UNITED STATES PATENT AND TRADEMARK OFFICE

Office Action Summary	Application No. 10/527,743	Applicant(s) MARUYAMA, YASUSHI	
	Examiner Brook Kebede	Art Unit 2823

DETAILED ACTION

FIG. 1A

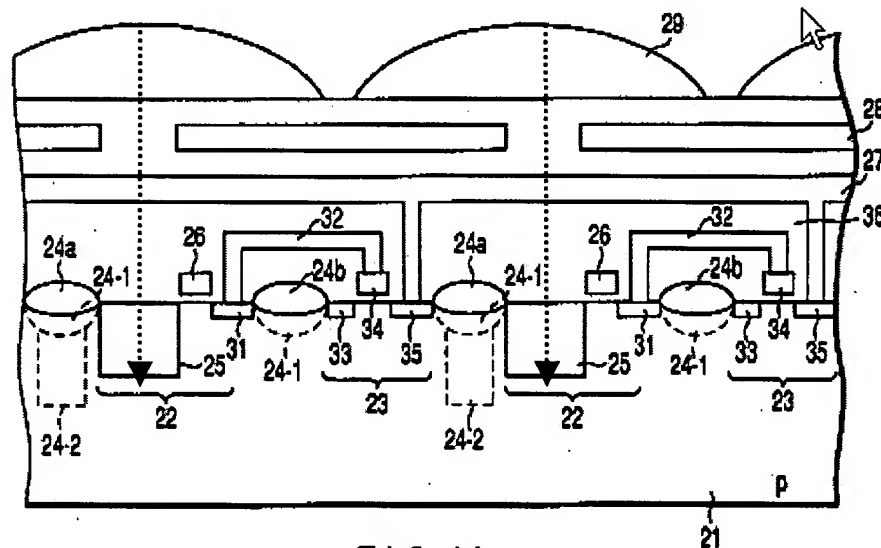
As depicted in Fig.1 above, Inoue et al. clearly show the microlens positioned to central part of photodiode. Inoue et al. also clearly disclose that the *focusing lens 29 is a microlens formed in each cell to form an optical image on the photodiode 25 of the cell*. In other word, the focal point of the lens 29 is directed toward the center of the photodiode 25. Further, The drawings, as shown in Figs. 1-3 clearly teach the claimed subject matter of the instant application.
